Item ID: D350-689-021 Accept ***N900040100*** Setup Start ***NS1***
 Revision ID: Stop ***NS2***
 Item Name: Dual High Back Seat, LH
 Start Date: 4/04/13 Start Qty: 1.00 ***1*** Cust Item ID:
 Required Date: 4/04/13 Req'd Qty: 1.00 ***1*** Customer:
 Reference:

DART SERVICE INSTRUCTION
TO AMEND INSTALLATION INSTRUCTIONS IIN-D350-689 REV. B
AND INSTRUCTIONS FOR CONTINUED AIRWORTHINESS ICA-D350-689 REV. 1
REF. TCCA STC: SH02-33
REF. FAA STC: SR01620NY
REF. EASA STC: EASA.IM.R.S.01453
REF. TCA STC: 2005S03-09

B-	CHANGES TO -013 KIT INSTALLATION. REF: CIR12-12.	MB	12.11.09
A-	NEW ISSUE	MB	11.12.22
REV.	DESCRIPTION	BY	DATE
DESIGN		DART AEROSPACE LTD	
DRAWN		HAWKESBURY, ONTARIO, CANADA	
CHECKED		DRAWING NO.	REV. B
MFG. APPR.	N/A	DSI 9588	SHEET 1 OF 6
APPROVED		TITLE	SCALE
DE APPR.		INSTALLATION CHANGE	NTS
DATE	12.11.09	COPYRIGHT © 2011 BY DART AEROSPACE LTD THIS DOCUMENT IS PRIVATE AND CONFIDENTIAL AND IS SUPPLIED ON THE EXPRESS CONDITION THAT IT IS NOT TO BE USED FOR ANY PURPOSE OR COPIED OR COMMUNICATED TO ANY OTHER PERSON WITHOUT WRITTEN PERMISSION FROM DART AEROSPACE LTD.

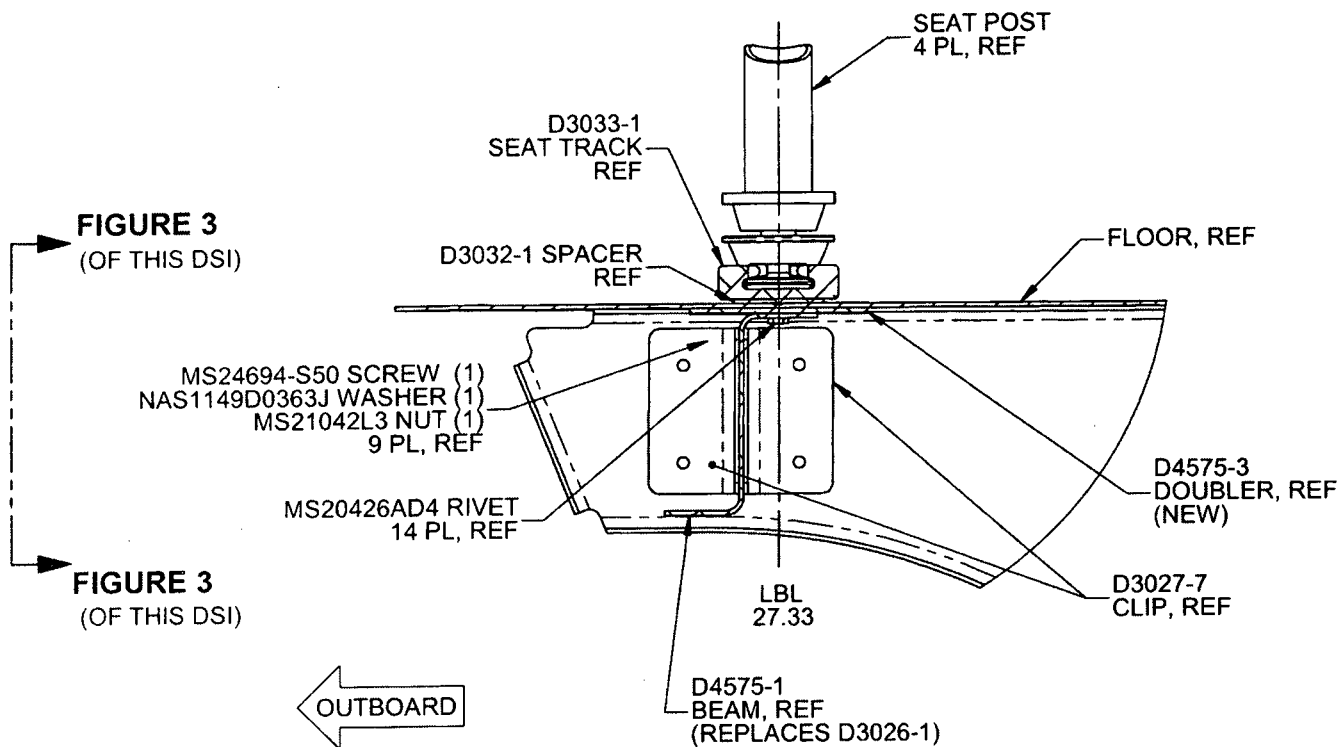
For D350-689-011/-013 at CHG 006/005 and later and D350-689-021/-023 Kits at CHG 005/004 and later, the D3026-1 Channel has been replaced with the D4575-1 Beam and D4575-3 Doubler and the D3234-3 Doubler has been removed. Consequently, the installation instructions for D350-689-011/-013 at CHG 006/005 and D350-689-021/-023 at CHG 005/004 are updated per Section 2.0 of this Service Instruction. The parts list update is shown in Section 4.0 of this Service Instruction. There is a negligible change to the weight and balance.

If there is an existing stringer at LBL 27.33, it will need to be removed from that location. Locate D4575-1 Beam and D4575-3 Doubler as shown in Figure 2 of this Service Instruction. Transfer drill existing holes from the aircraft floor to the D4575-1 Beam and D4575-3 Doubler. Ensure 1.0" to 1.5" rivet pitch and add additional holes if required. If there is no existing stringer, locate D4575-1 Beam and D4575-3 Doubler as shown in Figure 1 of this Service Instruction and drill Ø0.128" holes on a 1.0" to 1.5" pitch.

Note: Drill a Ø1.00" (Ø25.4 mm) hole in the D4575-1 Beam to clear extension tube of collective and cutout as required for clearance of collective opening and fwd bulkhead as shown in Figure 3 of this Service Instruction.

FIGURE 3: RELIEFS ON D4575-1/-3
(ONLY D4575-1/-3 SHOWN FOR CLARITY)
VIEW LOOKING INBOARD

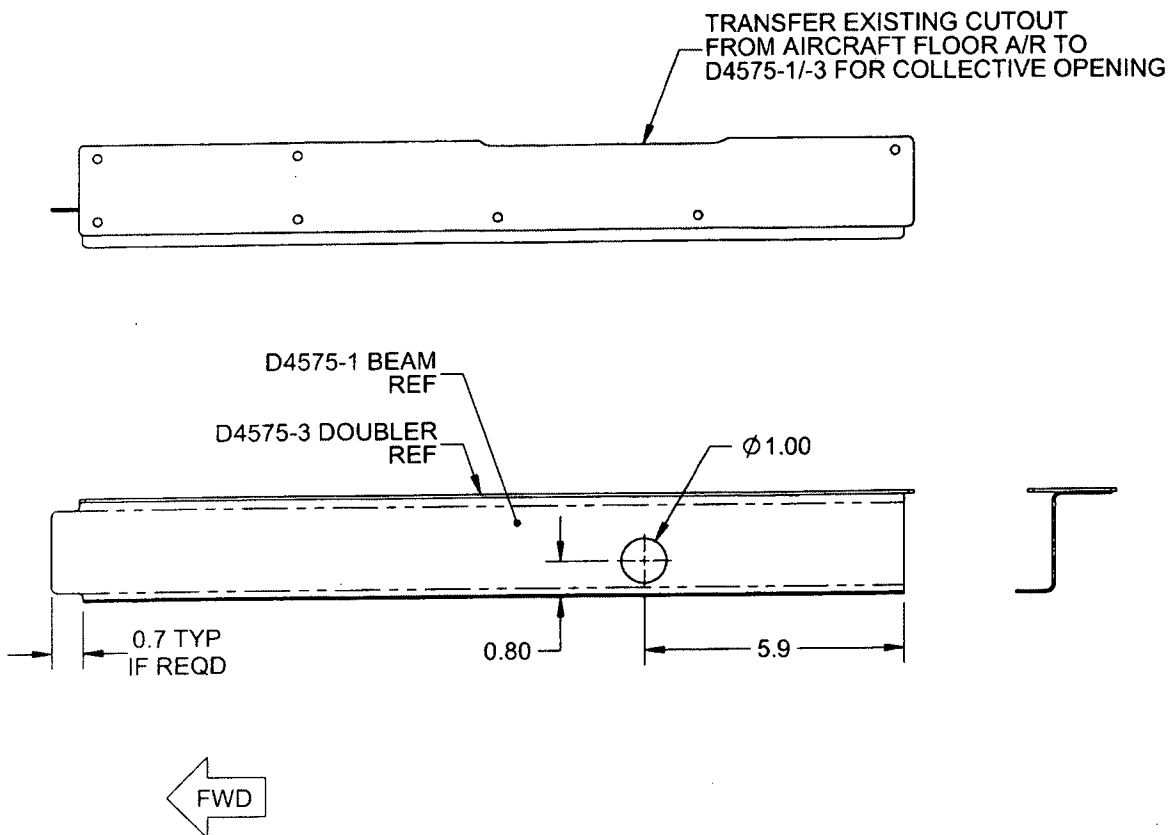
Note: Drill a Ø1.00" (Ø25.4 mm) hole in the D4575-1 Beam to clear extension tube of collective and cutout as required for clearance of collective opening and fwd bulkhead as shown in Figure 3 of this Service Instruction.
